Rezoning Transportation Analysis

Petition Number: 2022-146

Date	Description
1-25-23	First Review (IW)

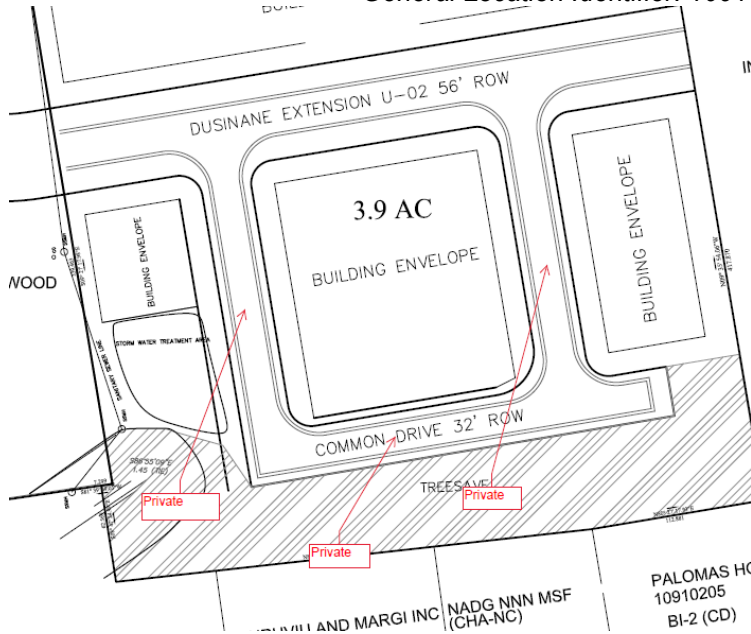
- 3. Revise site plan and conditional note(s) to commit to construct an 8-foot planting strip, and 5-foot sidewalk on Dusinane Extension per Chapter 20. The site plan shall label and dimension both items from the back of curb and gutter or edge of pavement.
- 4. Revise site plan to remove public right-of-way designation for private streets as shown below. Label and provide CLDSM designation for proposed private streets.
